Section 73 Planning Application Notes:

Project:
18021 Hammerstone Road Manchester

Sheet Name:
Proposed GA West Elevation

Project No. Orig. Zone Level Type Role Cls Dwg No. Rev
HRD-FRA-01-XX-DR-A-20-1209 **C03**

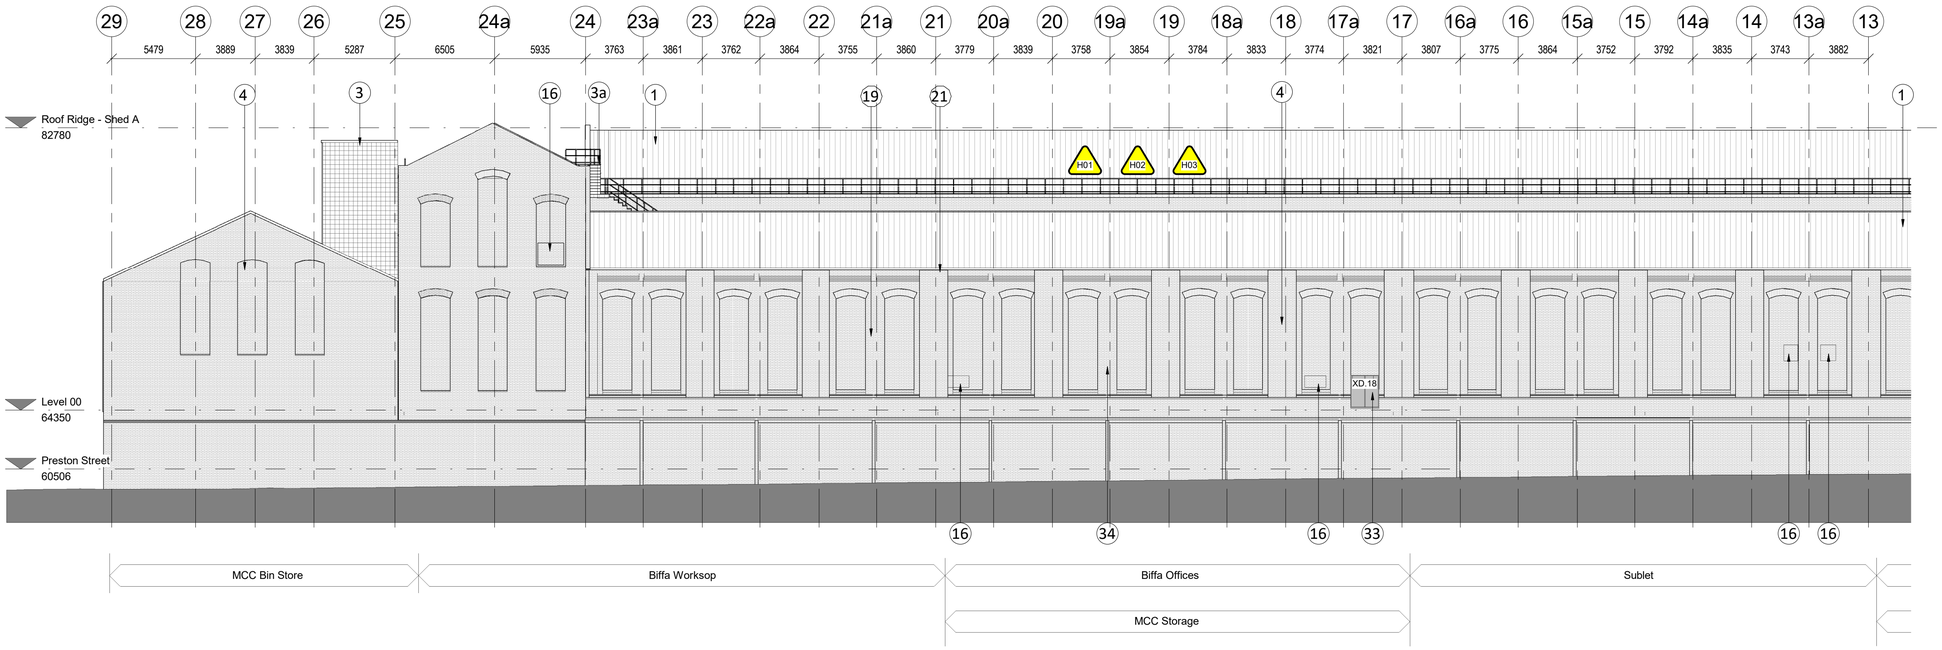
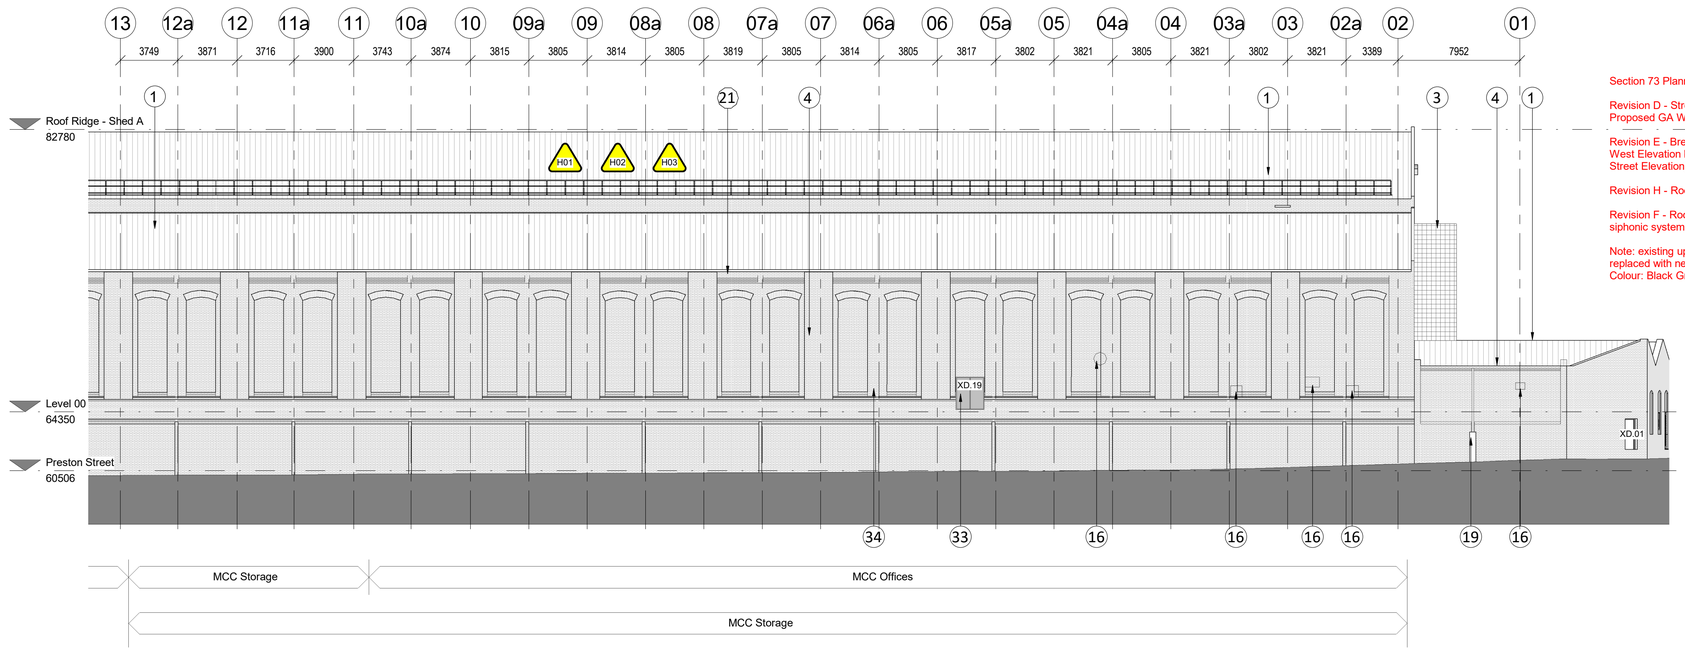
Revision D - Street level fire escapes omitted from the Proposed GA West Elevation (Preston Street Elevation)

Revision E - Break in panels added on the Proposed GA West Elevation between GL's 06-5a & 17a & 17 (Preston Street Elevation)

Revision H - Roof access walkway route updated

Revision F - Roof drainage changed from a gravity to a siphonic system, external rwps' omitted from GL'a A & G,

Note: existing upvc gravity rainwater pipes on GL's E, 24 &25 replaced with new aluminium rwp
Colour: Black Grey RAL 7021

Rev.	Description	Date	ISS	APP
C03	roof walkway routes co-ordinated with M.R. (Site Services) drawing 001 B	2023.07.07	AT	AT
C02	External door & window refs added	2022.11.01	AT	AT
C01	Construction Issue, notes 19 ameded, 25 omitted, 34 & 35 added, rwps omitted, break in panel size amended to line wit existing masonry reveals	2022.07.20	AT	AT
